# Conceptual Site Plan 1990 Brightseat Road Property

## CSP-13006-01

STAFF REPORT

SUBJECT: Conceptual Site Plan CSP-13006-01  
Type 1 Tree Conservation Plan TCP1-001-14-01  
1990 Brightseat Road Property

**Figure 1: Conceptual Site Plan**

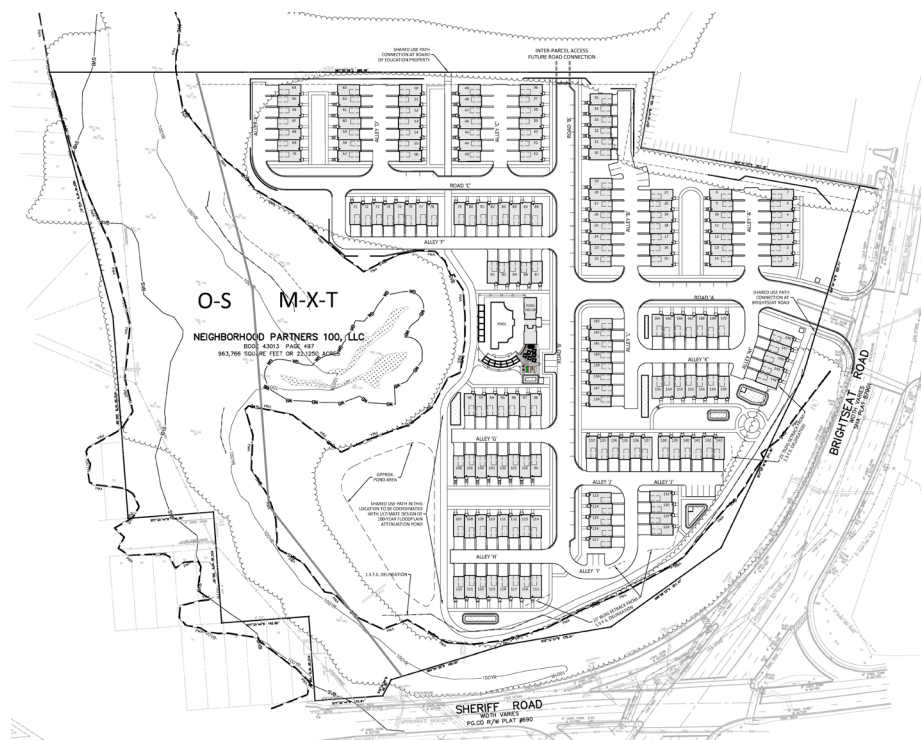
**Note:** \*The gross tract area on the various plans submitted is represented as 22.12 acres and 22.15 acres. A condition has been provided herein, to correct the acreage to be consistent on all plans.

\*\*The gross floor area (GFA) proposed is not provided on the conceptual site plan (CSP). A condition has been provided herein, to include the GFA in the CSP general notes.

\*\*\*The floor area ratio (FAR) proposed is not provided on the CSP. A condition has been provided herein, to provide a FAR table on the CSP.

1. Prior to certification of approval of the conceptual site plan (CSP), the following revisions shall be made, or information shall be provided:
  - a. Correct the acreage of the site to be consistent on all plans.

- b. Provide the gross floor area in the general notes.
  - c. Provide a floor area ratio table on the CSP.
  - d. Revise the natural resources inventory to correct the Site Statistics Table and the specimen tree information.

**Figure 2: Impacts proposed due to non-woody buffer**

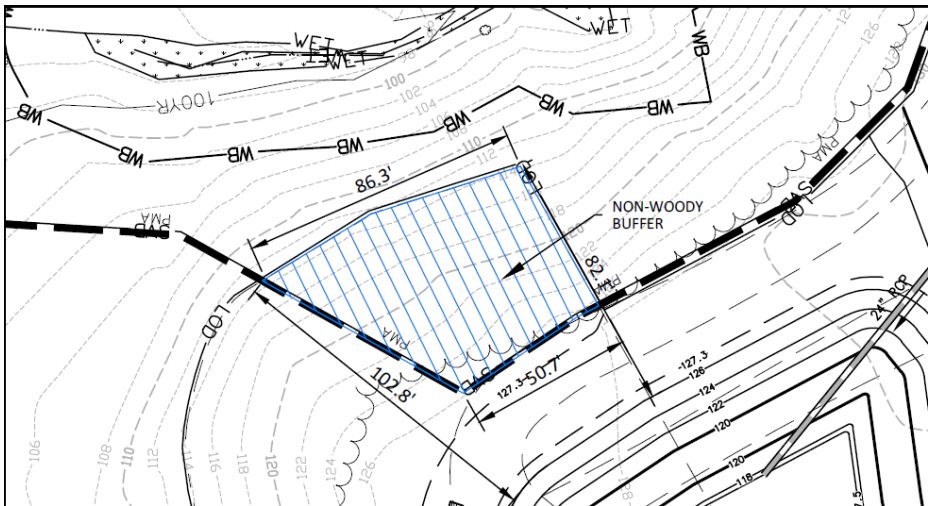
These impacts, which are in two areas and shown in exhibits 4 and 7, are for the establishment of a required non-woody buffer to the 100-year attenuation pond for a disturbance of approximately 8,125 square feet (0.19 acre). These impacts can be avoided if the pond is repositioned.

This impact is not supported as proposed because the proposed grading for the non-woody buffer can be designed to avoid impacts to the PMA by shifting the location of the pond.

- (4) Revise the CSP and TCP1 to remove the primary management area impacts for the proposed stormwater management pond non-woody buffer.
- (5) Enhance the Limit of Disturbance line, so it is easier to read.

# TYPE I TREE CONSERVATION PLAN

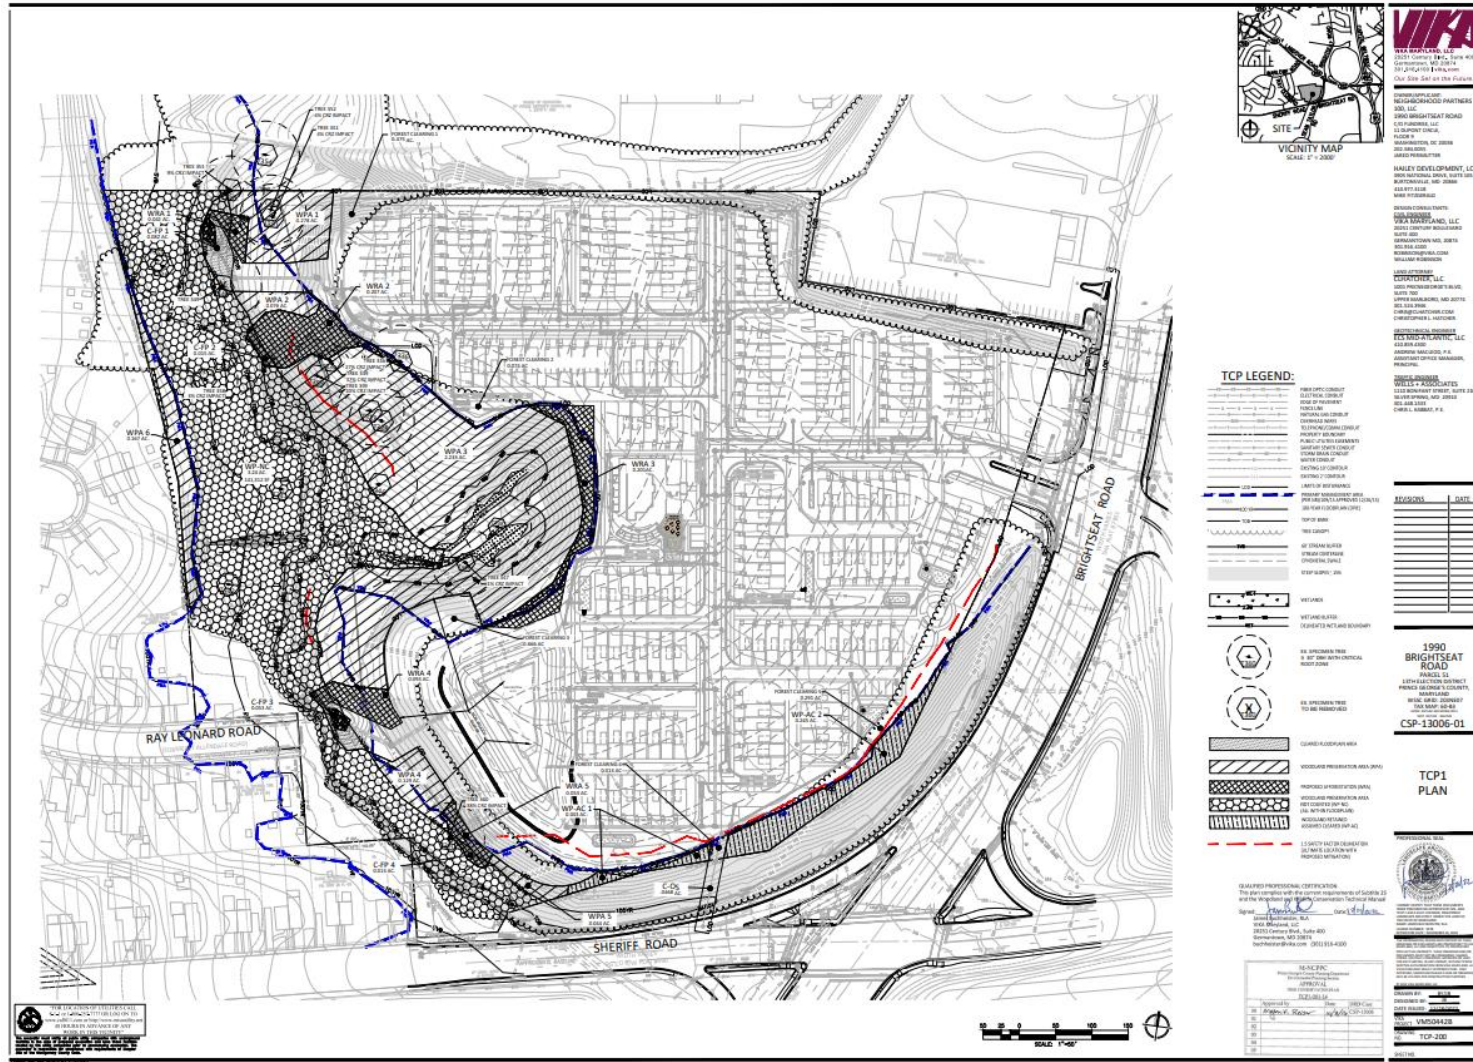
A geotechnical report and slope stability analysis was submitted with this application and reviewed by the Commission's Geotechnical expert. The 1.5 factor safety line is correctly shown on the TCP1; however, the 25-foot setback line is not being shown on the plan. Prior to certification of the CSP, the TCP1 shall be revised to show the 25-foot setback line from the 1.5 Safety Factor Line.

- e. Revise the Type 1 tree conservation plan (TCP1) as follows:
    - (1) Show the 25-foot setback line from the 1.5 Safety Factor Line.
    - (2) Revise the information on the TCP1 Site Statistic Table with the data on the revised natural resources inventory plan.
